**Finland Ukraine Trust Fund,
FI05/07/2020, NAT-018-DP
Design, Construction, Delivery and Erection
of Prefabricated Modern Diagnostic
Laboratory for Volyn Regional Children and
Mother Hospital**

Tender Q&A

28 May 2021

PRELIMINARY LAYOUT Delivery Scope Specification for tender

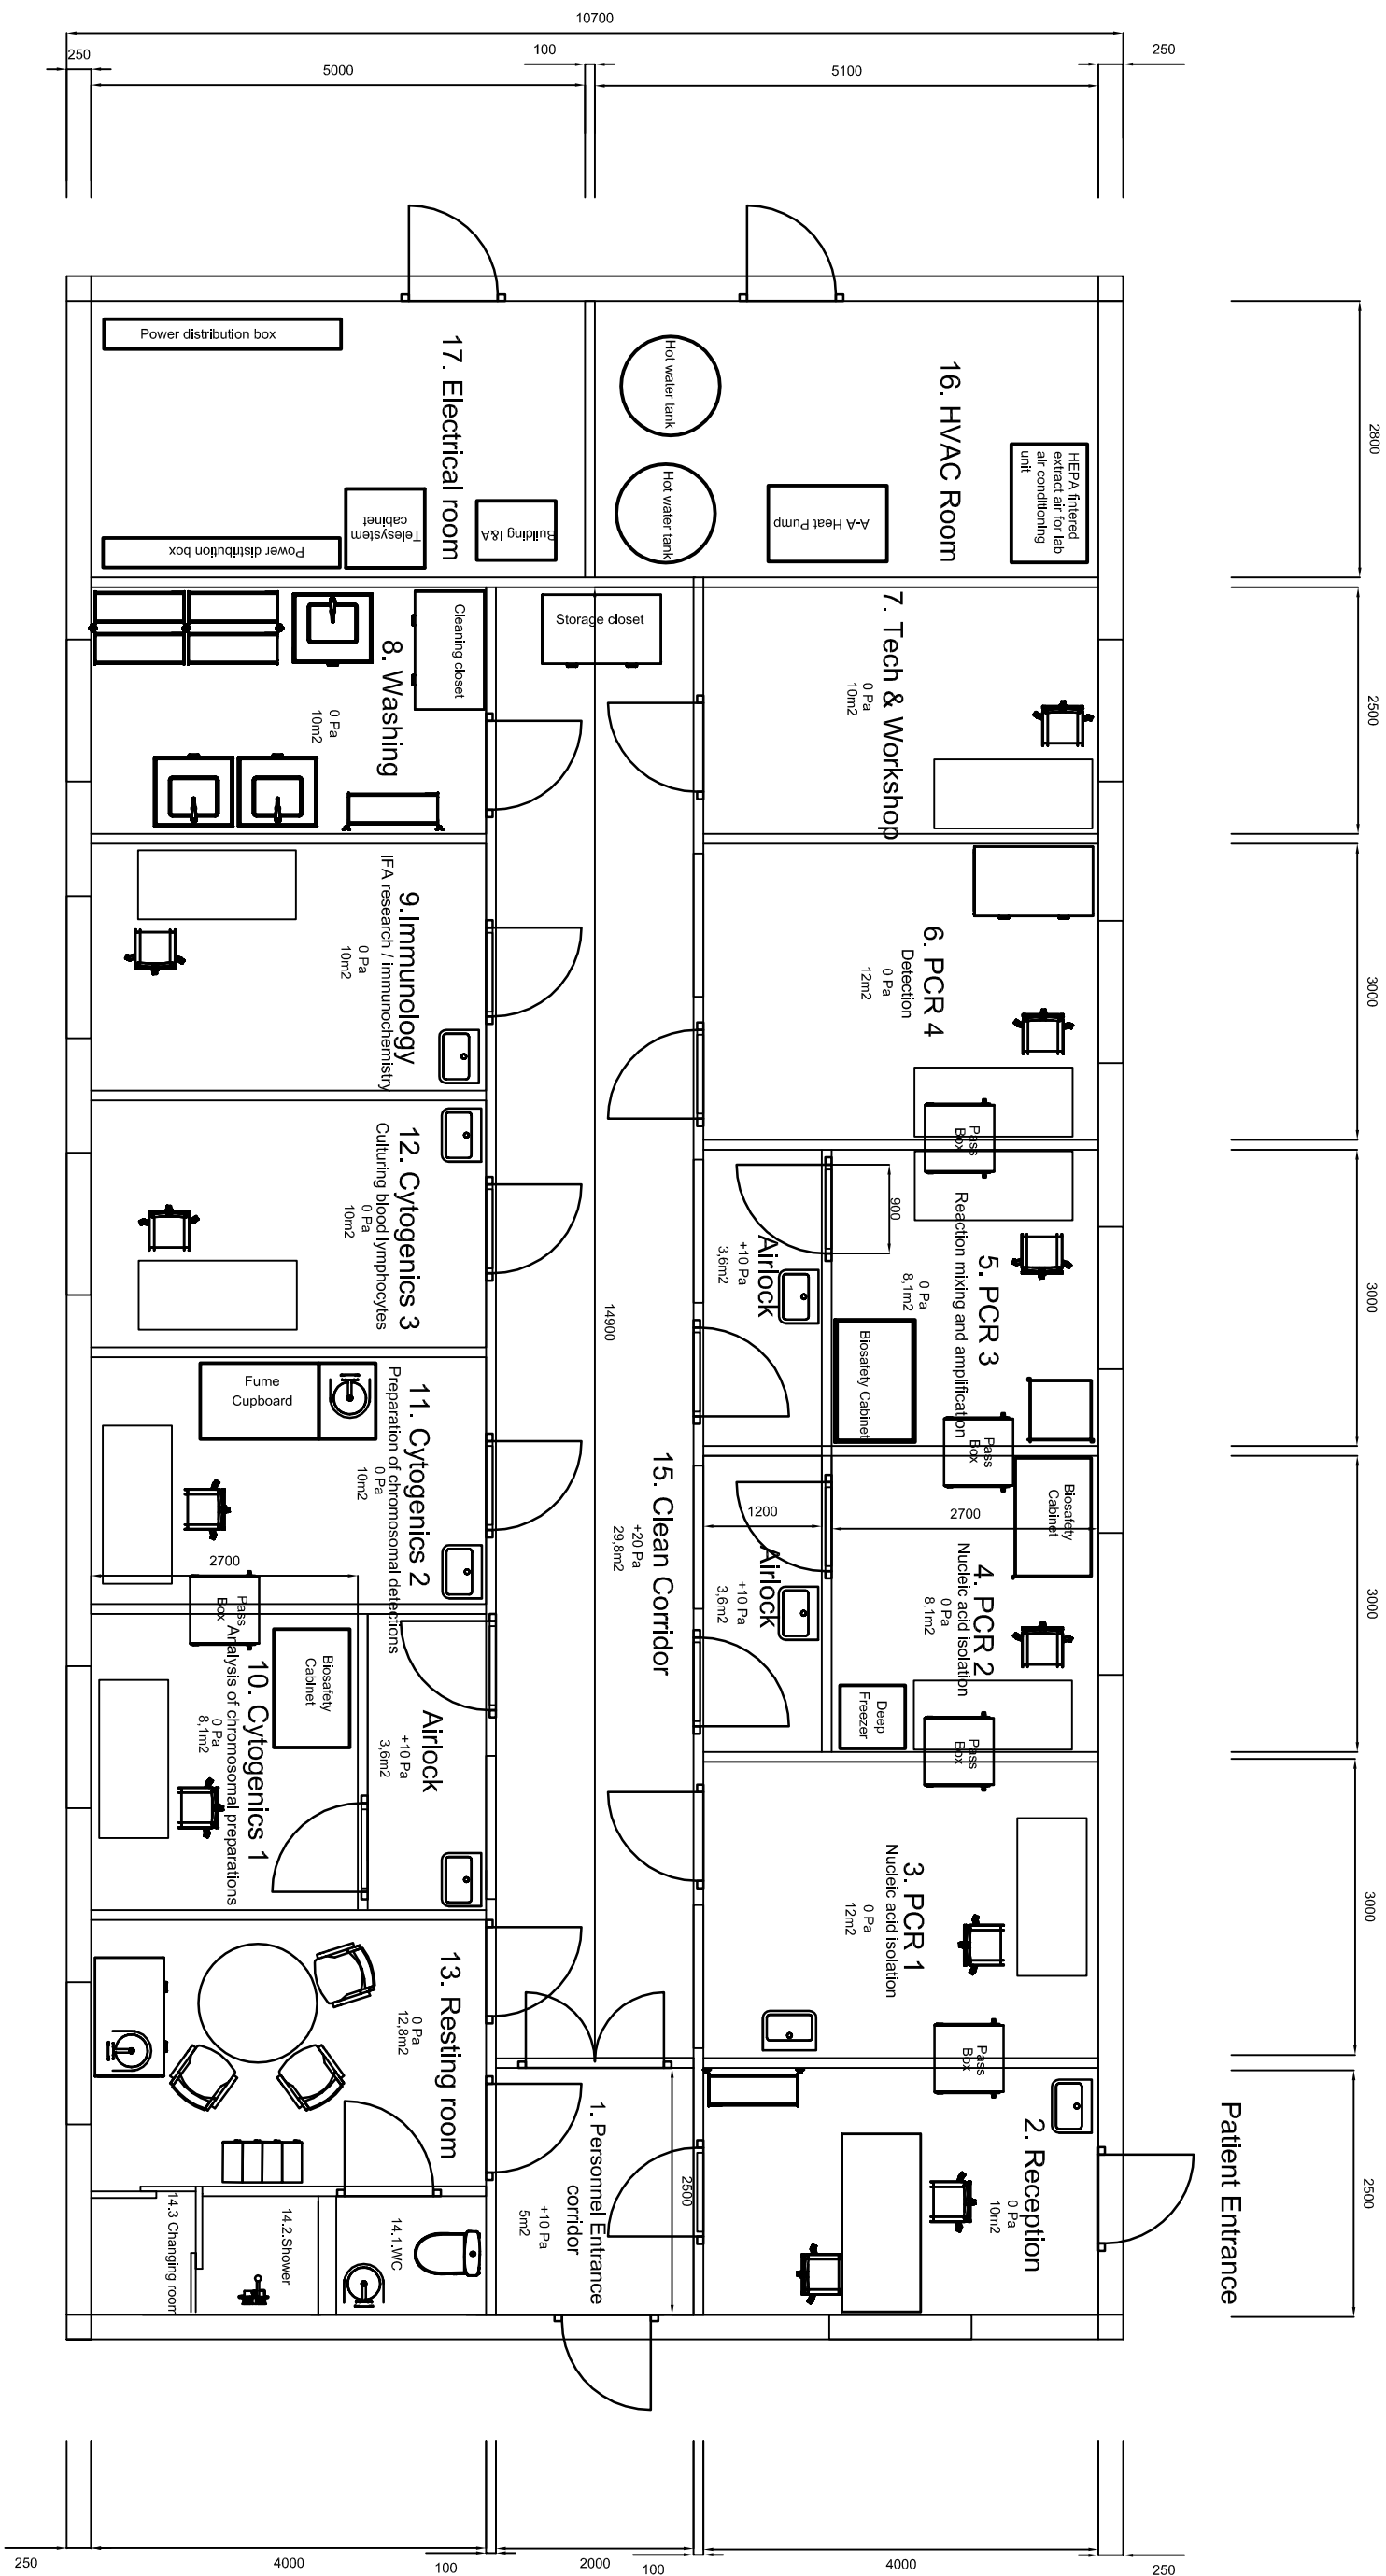
23	AHUs + heat recovery units need to be shown in the layout.	See above (22).
24	In HVAC room, there are two circles, pls explain. Hot water generation?	Preliminary indication of the hot water system and tanks.
25	Electrical cabinet for HVAC is normally in the HVAC room.	The room layout is preliminary. It is up to the Bidder to locate their equipment the technical rooms.
26	Could you clarify the requirements for fire proof materials (Invitation to Tender, page 12/60)	The laboratory is one fire area. Therefore, the fireproof requirements for interior structures (like interior doors and walls etc.) are not valid.
27	Who is counterparty and who is final beneficiary.	The Beneficiary and Client is the The Volyn Regional Mother and Child Hospital.
28	If a contract is signed with a building element manufacturer, who is their speaking partner? You? Any local contact person?	Volyn Mother and Child Hospital Administration is the main speaking partner. NEFCO is the financier, and Elomatic as Coordination and Management Consultant is supervising the project on behalf of NEFCO.
